ADDENDUM 2
VALLEY VIEW SHOPS - ROANOKE, VA
12/15/16
ADTA PROJECT NO: 16004.11

COMMERCIAL BUILDING UPGRADE

UTILITY RELOCATION PLAN

C102

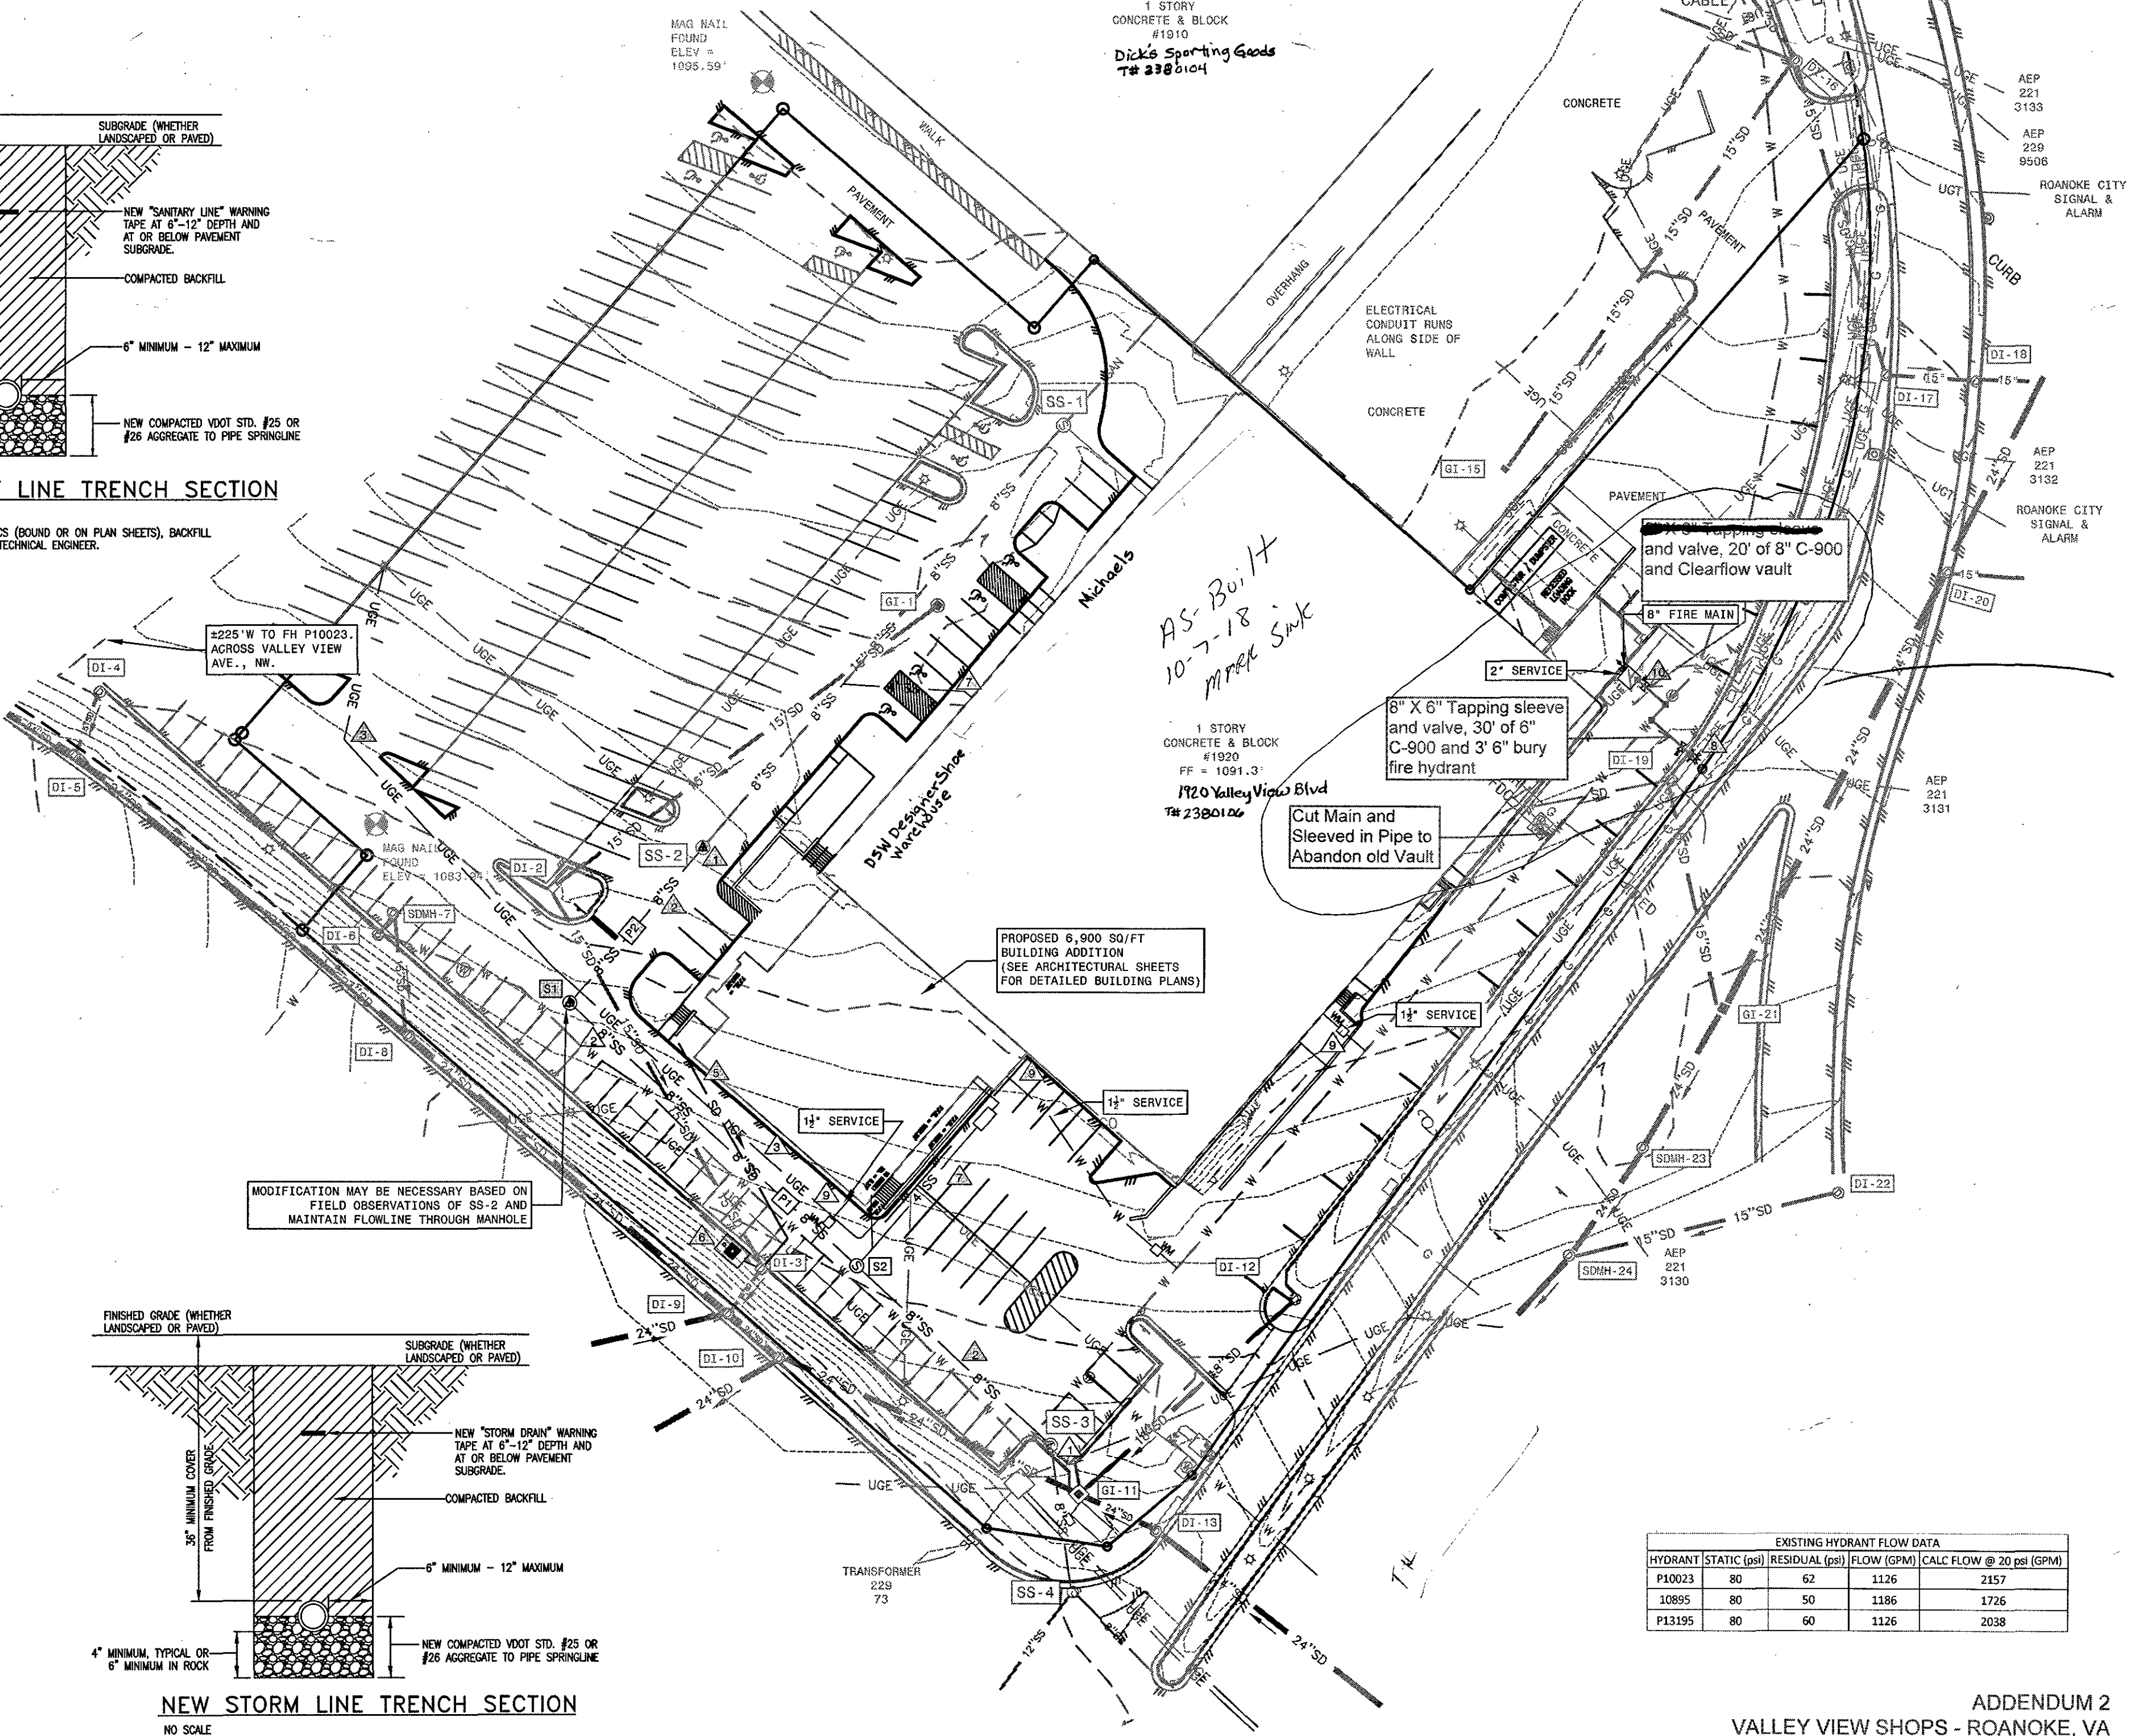
NOTES:
SANITARY SEWER SECTION FROM SS-1 THROUGH S1 TO SS-3 ASSUMED BASED UPON LIMITED FIELD SURVEY OF SS-2. SS-2 LOCATION AND INVERT ELEVATIONS TO BE FIELD VERIFIED PRIOR TO BEGINNING ANY SANITARY SEWER DEMOLITION OR RELOCATION. CHANGES NECESSARY TO SANITARY SEWER DESIGN TO BE VERIFIED OR PERFORMED BY ENGINEER.
